PRODUCT SAFETY NOTICE CORRECTIVE ACTION

DEWALT DWS780-XE and DHS780 305mm Mitre Saws

REAR GUARD COMPONENT LOCATION AND IDENTIFICATION

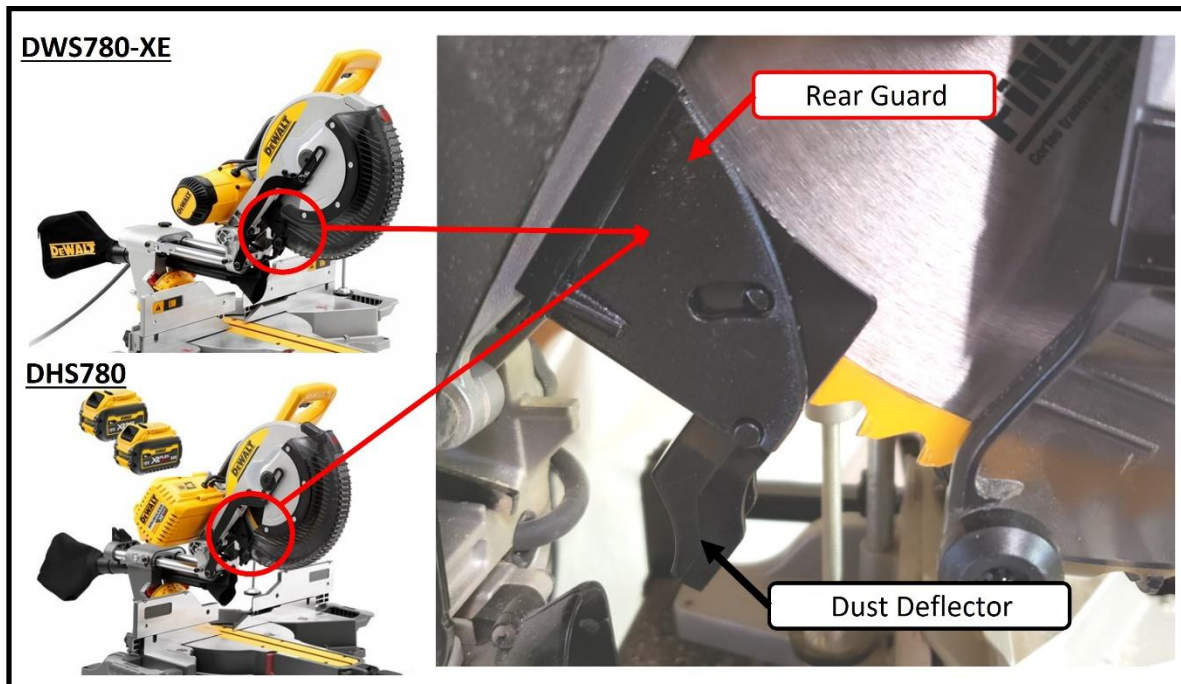
Defect: The rear guard may break or detach and make contact with the saw blade.

Hazard: If the rear guard contacts the saw blade, fragments may be thrown from a rotating blade contacting the operator or bystander and causing injury.

The repair kit includes a new rear guard and dust deflector assembly, two new fixing screws and instructions. The original saw blade wrench supplied with the saw, which is used to change saw blades, has a T30 Torx head and can be used to remove the old screws and replace the new screws.
